GE INNOVATION POINT

Fort Point Channel Landmark District Review

October 12, 2017

DESIGN UPDATES **TABLE OF CONTENTS**

ROOF TOP CLADDING - MECHANICAL SCREEN AS APPROVED

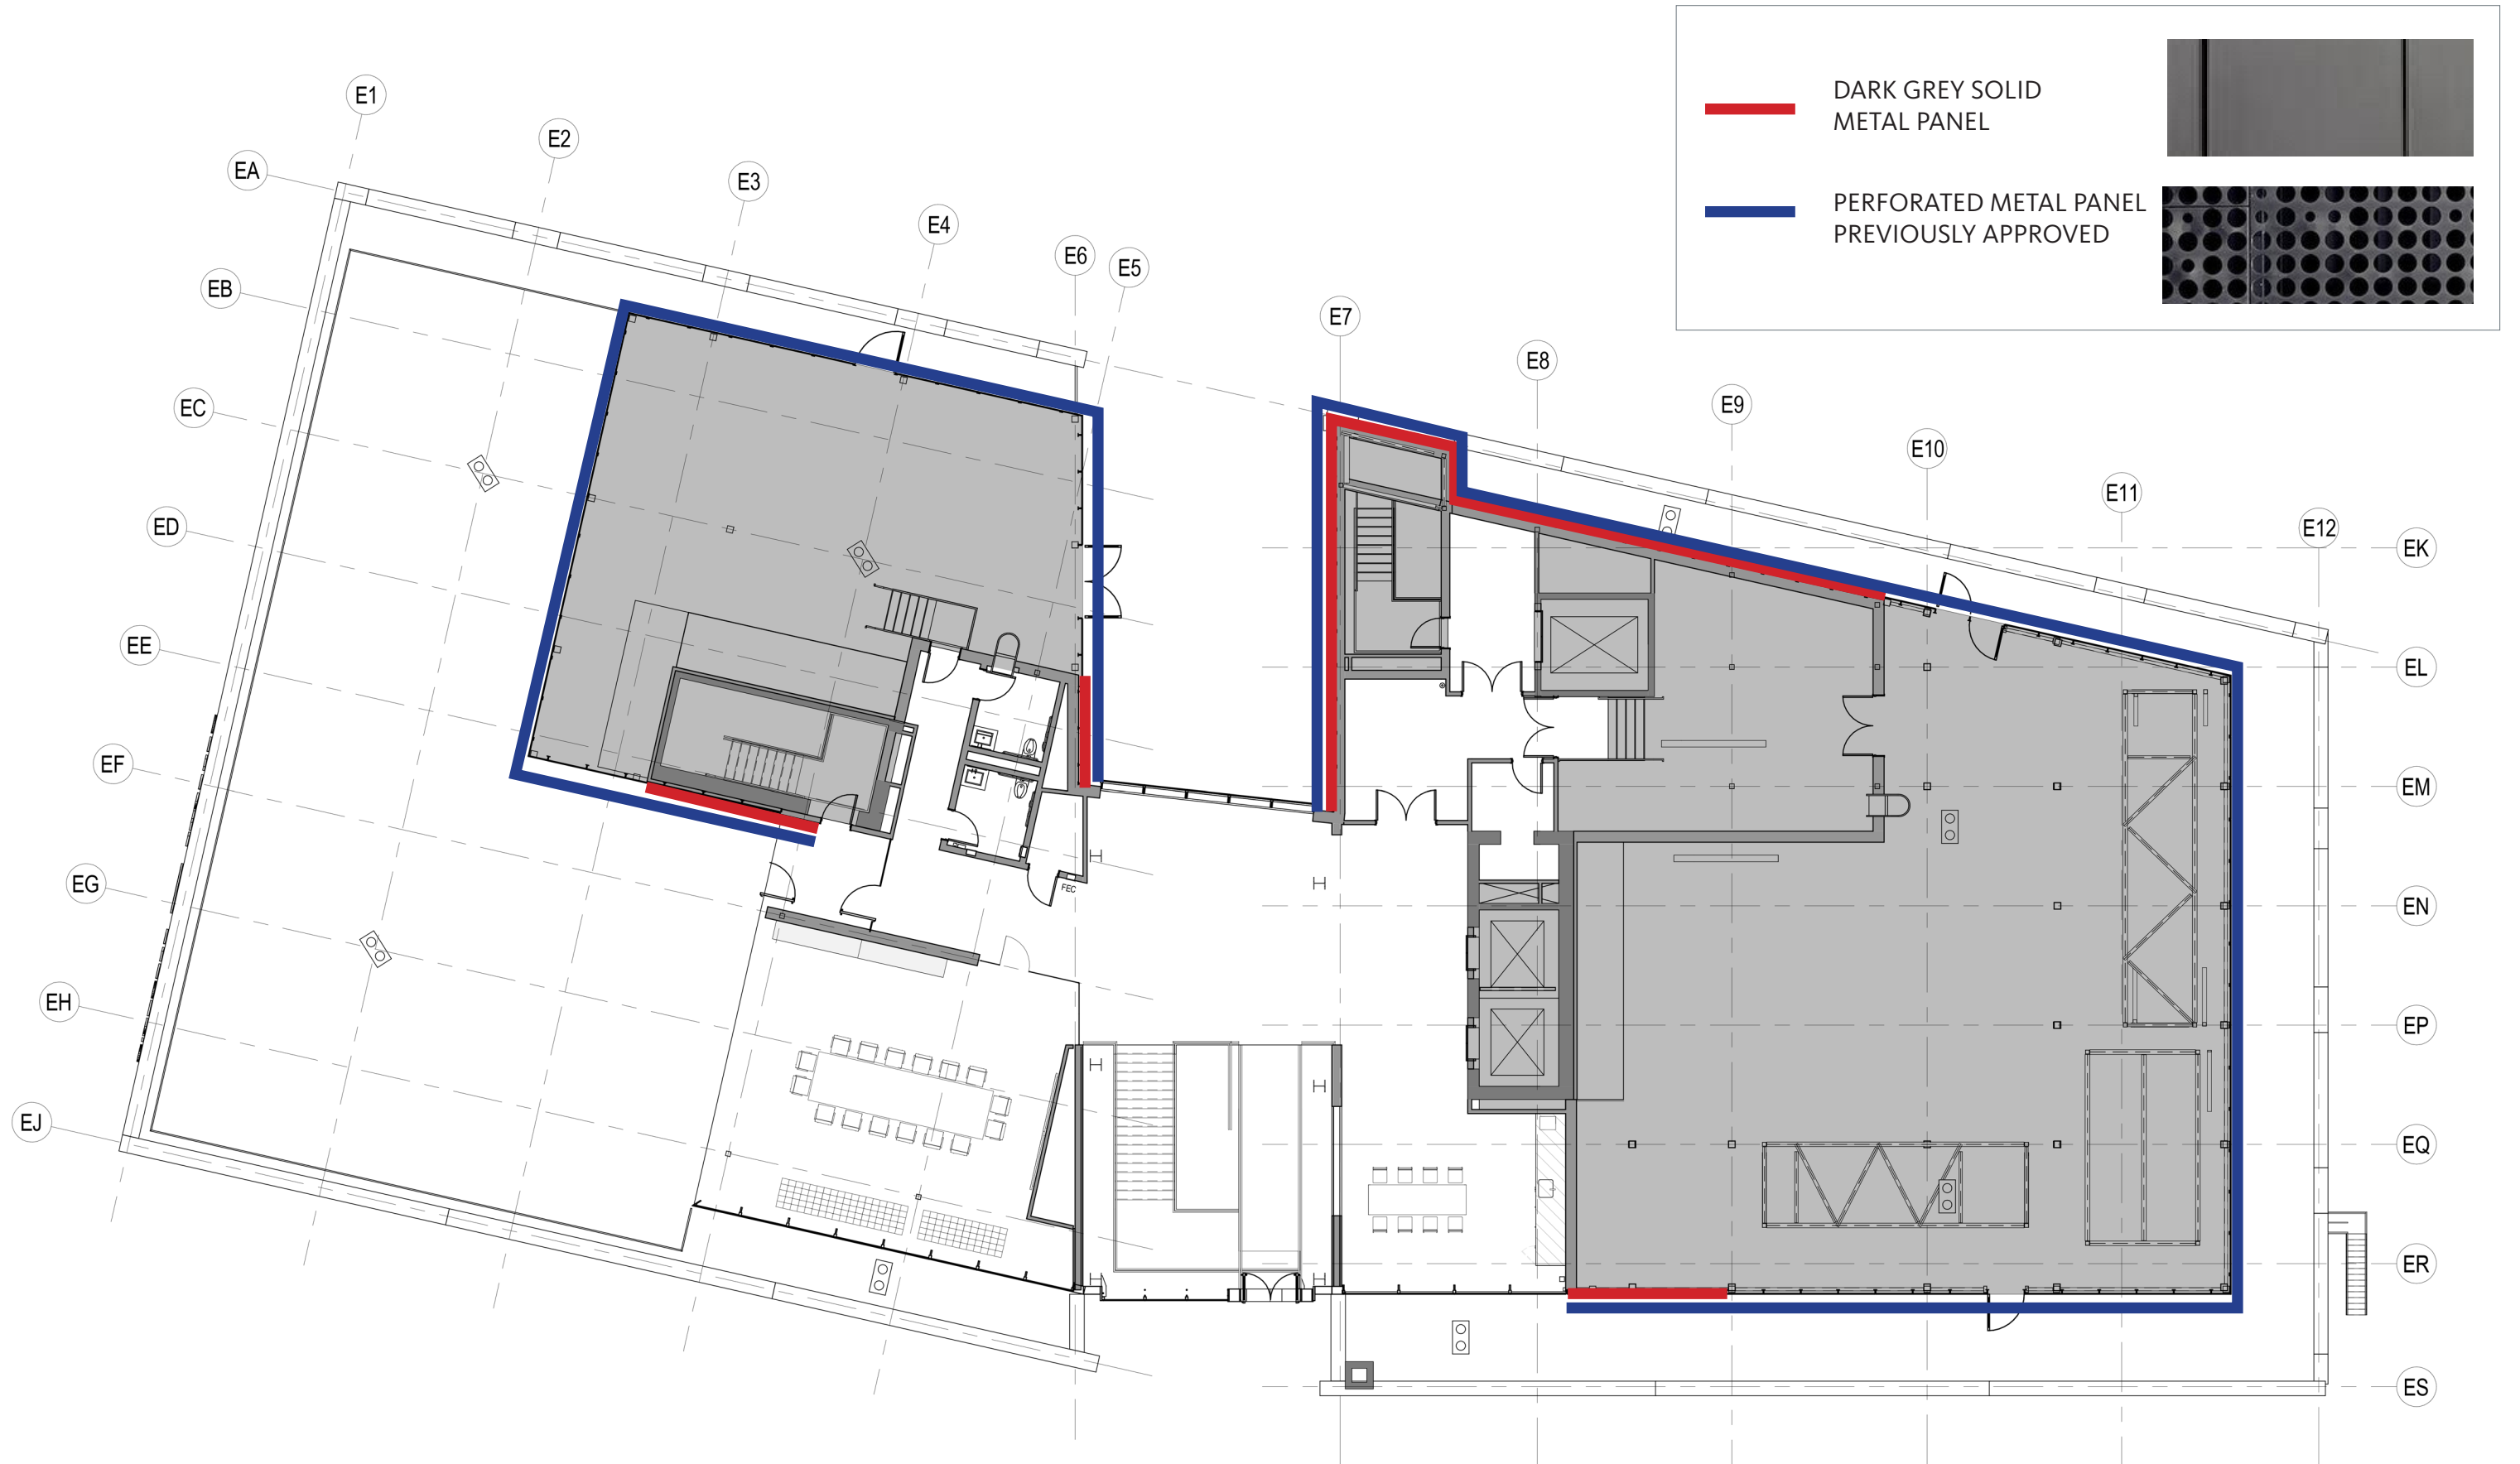
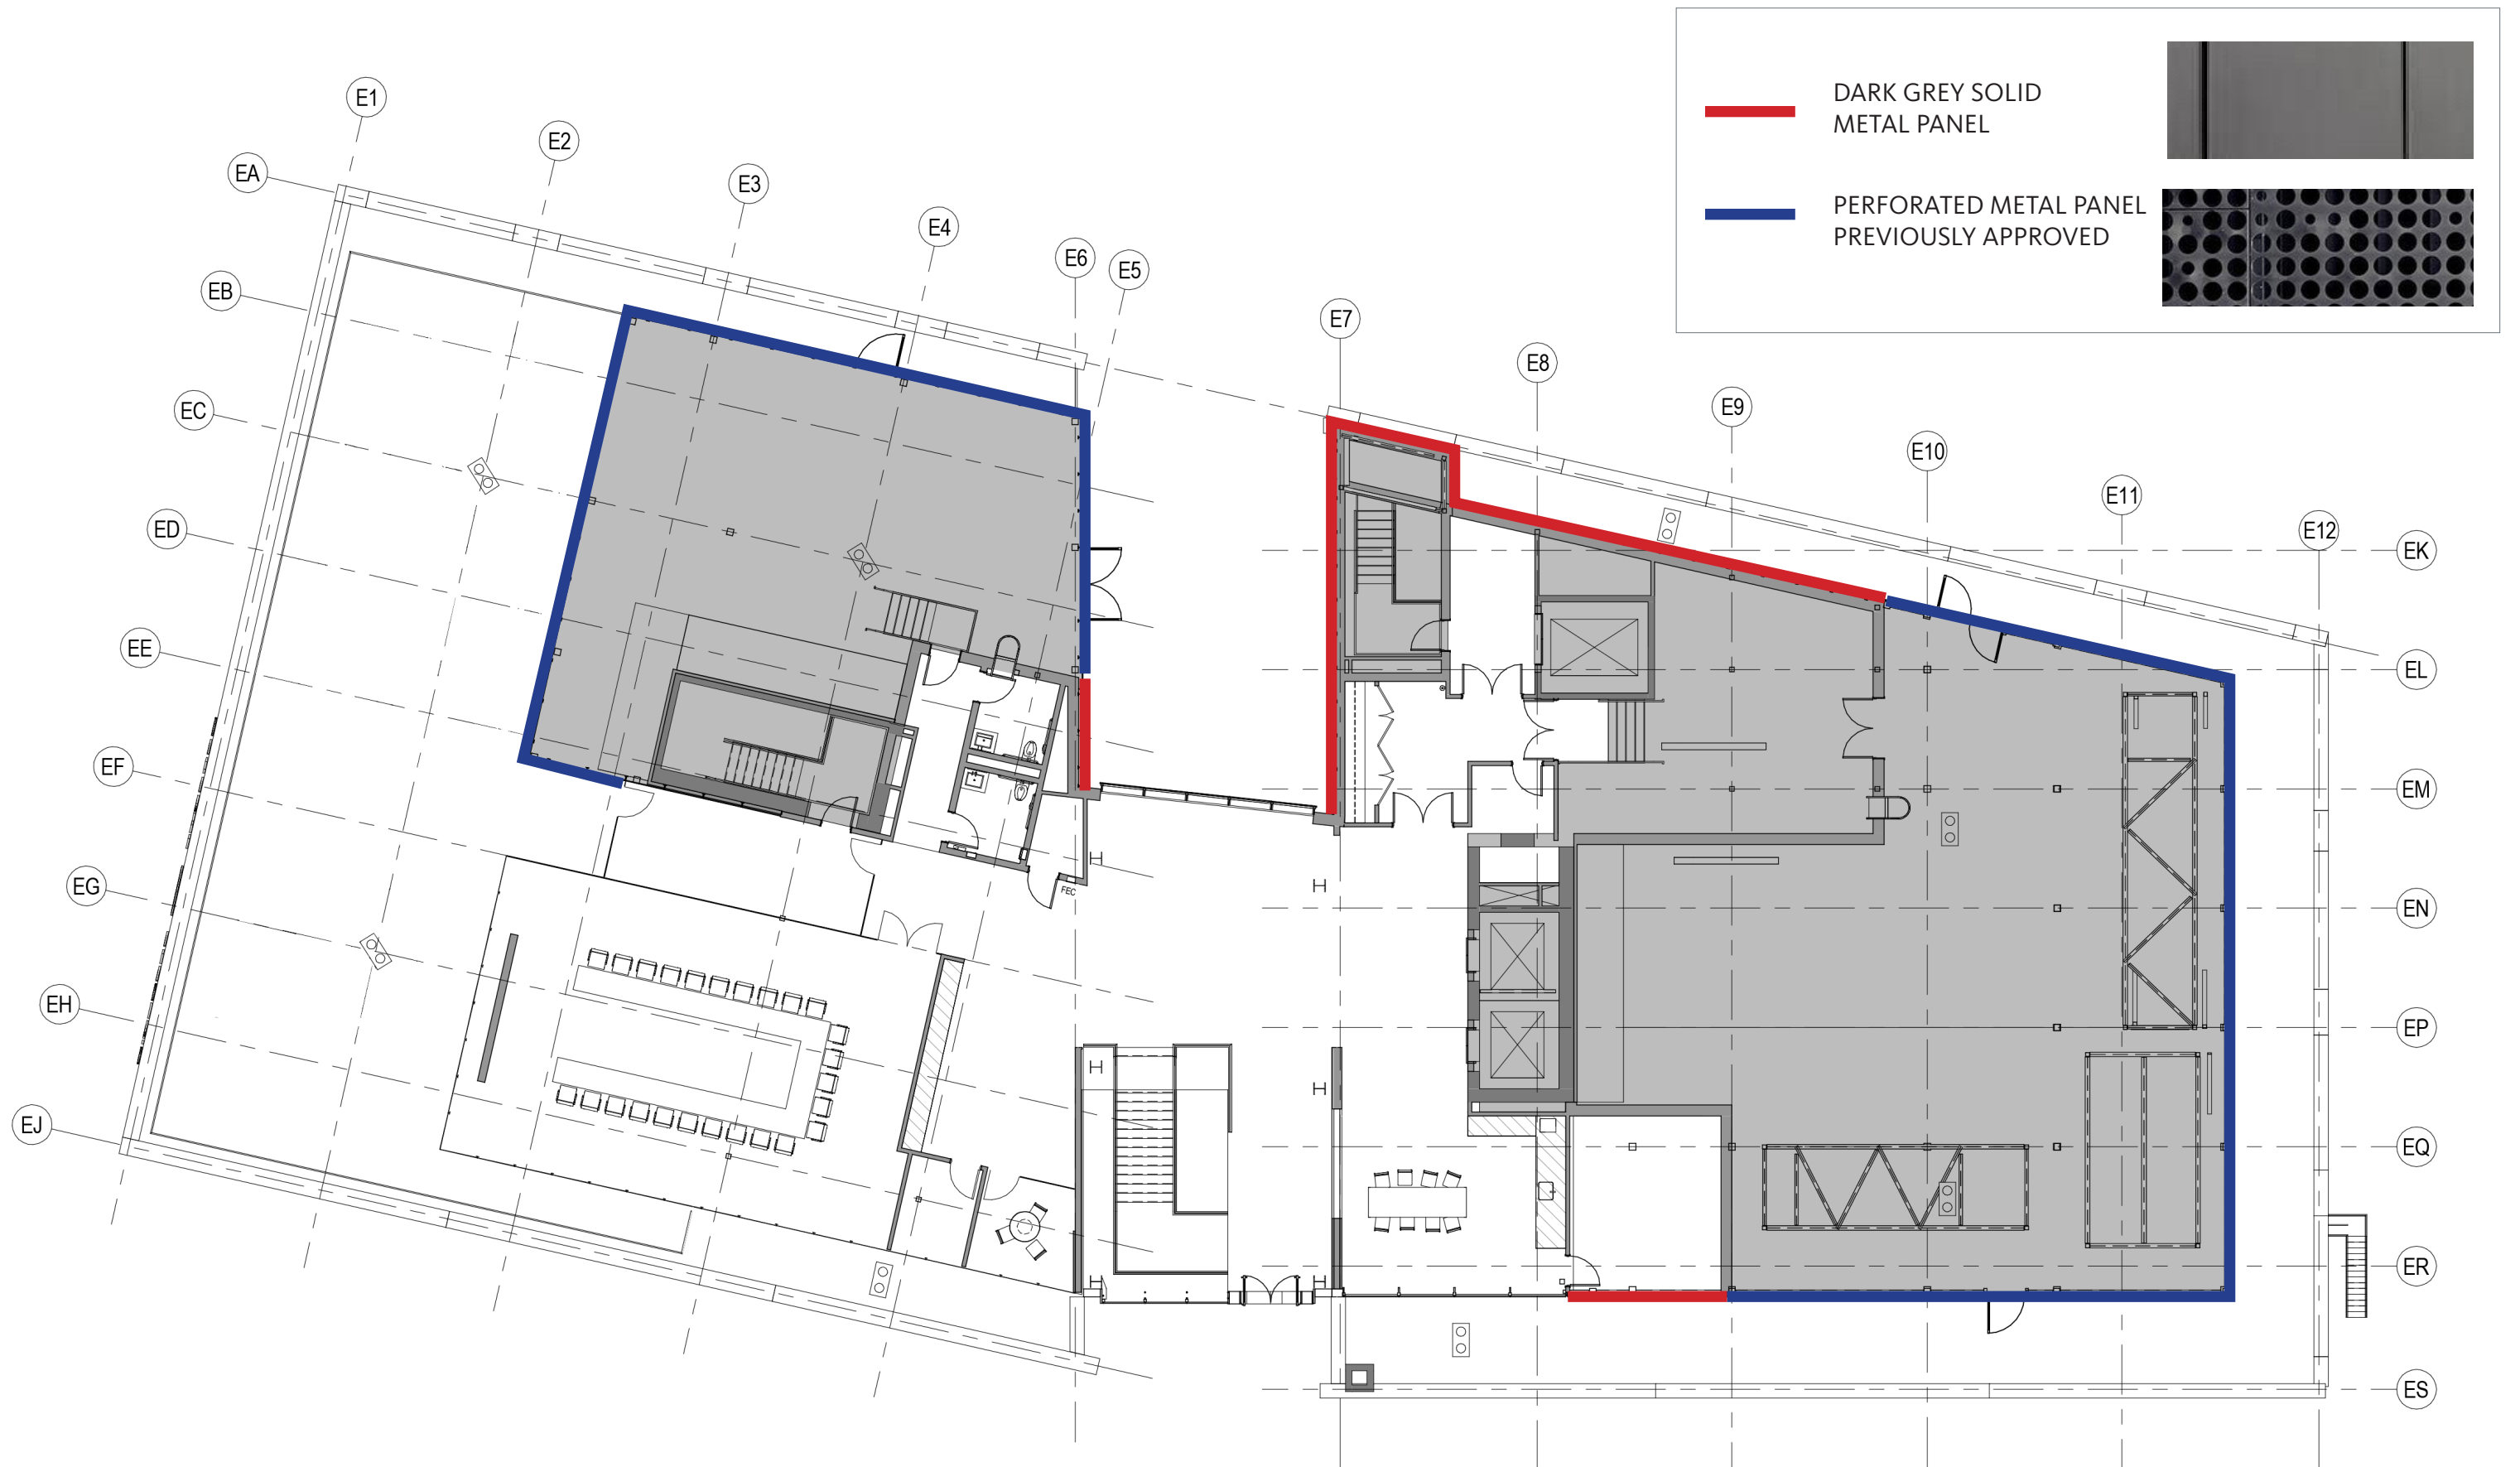
ROOF TOP CLADDING - MECHANICAL SCREEN PROPOSED
